Access Compliance Report

Public Rights-of-Way

(Curb Ramps)

Intersection ID: 52622	Main Street: HERITAGE_POND_DR	Cross Street: ALEXANDER_COMMONS_DR	Location: W
ADA ID: 2716DD8BDE1F	Ramp Type: Perp	Initial Pass/Fail: Fail	Overall Compliance: No
Codes/Mitigation Info/Possible Solution			Severity Score: 25
			Field Measurements/Component Compliance

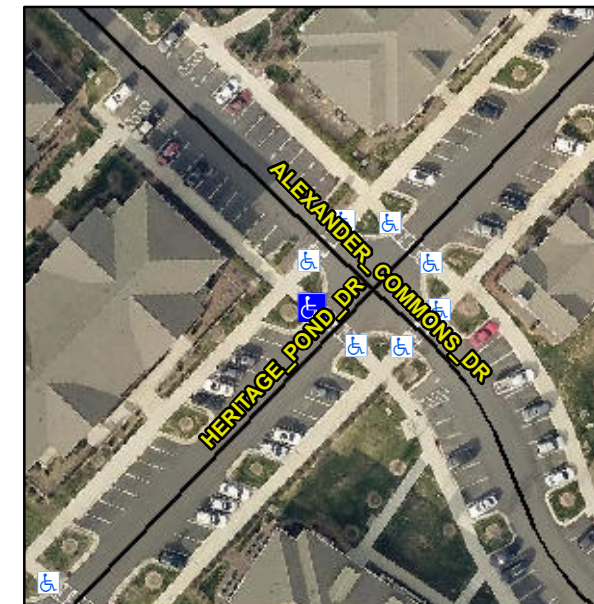
Compliance	Description	Data	Compliance	Description	Data
N/A	Ramp Length (in)	92.0	No	Ramp Slope (%)	14.2
Yes	Ramp Width (in)	90.5	Yes	Ramp XSlope (%)	1.6
N/A	Flare Type LT	N/A	N/A	Flare Type RT	N/A
N/A	Flare Slope LT (%)	N/A	N/A	Flare Slope RT (%)	N/A
N/A	Flare Traversable LT?	N/A	N/A	Flare Traversable RT?	N/A
N/A	Landing Length (in)	N/A	N/A	DWS Provided?	N/A
N/A	Landing Width (in)	N/A	N/A	DWS Contrast?	N/A
N/A	Landing Slope (%)	N/A	N/A	DWS Length (in)	N/A
N/A	Landing X Slope (%)	N/A	N/A	DWS Full Width?	N/A
N/A	Landing Curb? (Y/N)	N/A	N/A	DWS Offset (in)	N/A
N/A	Shared Landing?	N/A			
N/A	Gutter Ponding?	N/A	N/A	Gutter Slope (%)	N/A
N/A	Gutter Lip Ht (in)	N/A	N/A	Gutter X Slope (%)	N/A
N/A	Painted X Walk1?	Yes	N/A	Painted X Walk2?	N/A
	X Walk 1 Direction	To SE		X Walk 2 Direction	N/A
N/A	X Walk 1 Width (in)	89.5	N/A	X Walk 2 Width (in)	N/A
	X Walk 1 Slope (%)	4.7		X Walk 2 Slope (%)	N/A
	X Walk 1 X Slope (%)	1.1		X Walk 2 X Slope (%)	N/A

Remove & Replace Entire Ramp.

R304.2.2
